| 8802-3/802.3 REVISION REQUEST 1220 |

DATE: 8th of March, 2009
NAME: Marek Hajduczenia
COMPANY/AFFILIATION: ZTE Corporation
E-MAIL: marek.hajduczenia@zte.com.cn
REQUESTED REVISION:
STANDARD: IEEE 802.3av-2009
CLAUSE NUMBER: 77.2.2.7
CLAUSE TITLE: State diagrams

77-14 Modifications to ONU Control Multiplexer state diagram

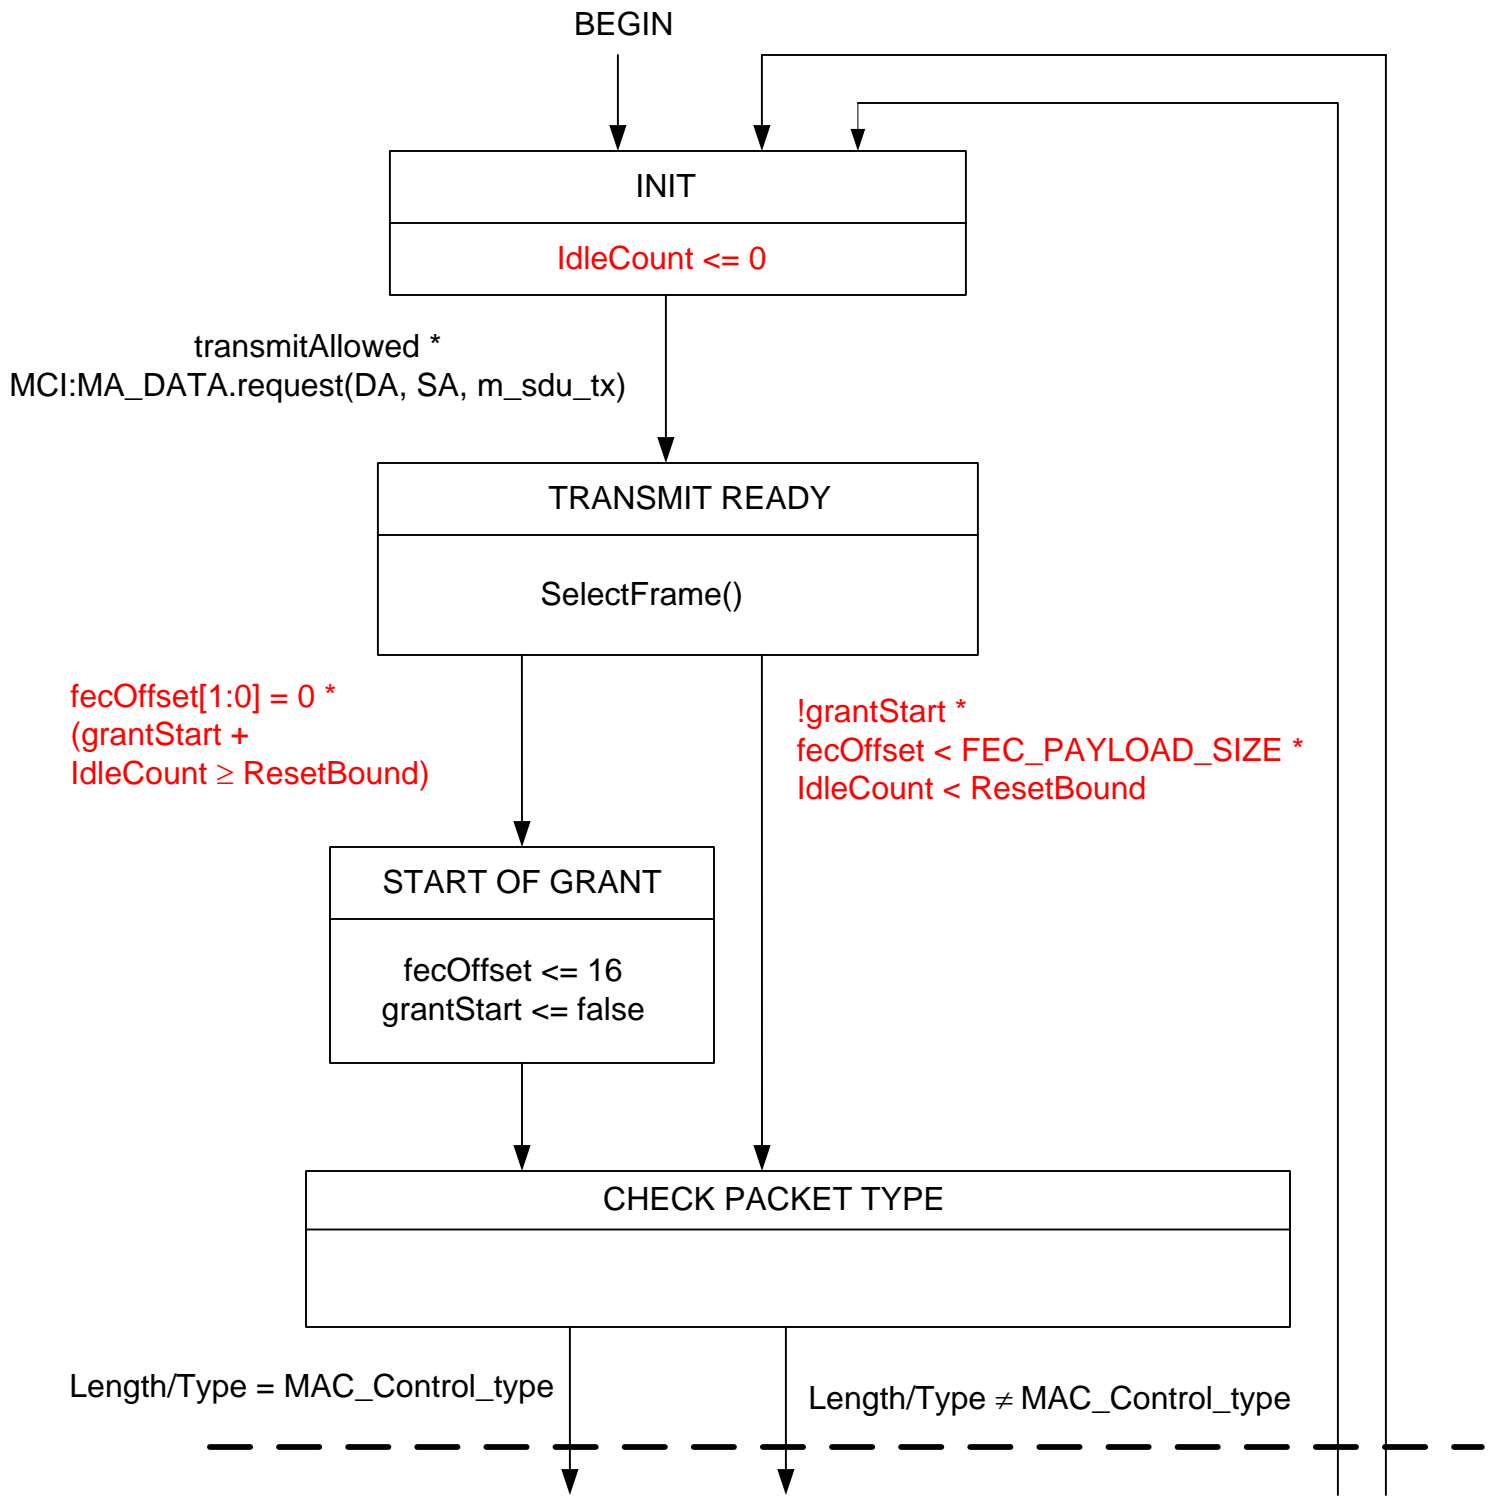
[1] Change the top part of Figure 77-14 as proposed in attached file "Attachment 1.pdf"

A 10G-EPON ONU may be granted a large timeslot and not have sufficient data to fill this allocated time-slot. According to Figure 76-17, the laser shall be switched off when no data is transmitted. When more data becomes available at the ONU during the allocated time slot, laser will be switched on again. However, the variable fecOffset may become misaligned since it is reset only at the beginning of the time-slot.

When the transmission within the time-slot is restarted, the variable grantStart is not reset to true and the variable fecOffset will have some arbitrary value (depending on how long the gap in the allocated time-slot was), which may result in incorrect calculation of FEC position. This in turn may cause the transmission extend beyond the intended time-slot by up to 1 FEC codeword.

[2] Add variable to 77.2.2.3 Variables

ResetBound = 8 * DelayBound

TYPE: 16-bit unsigned

This variable represents the value of DelayBound (76.3.1.2) expressed in units of octet time.

[3] Add variable to 77.2.2.3 Variables

IdleCount

TYPE: 32-bit unsigned

This variable represents length of gap between subsequent frames, expressed in the unit of octet time. This variable advances by 1 after every 8-bit times.
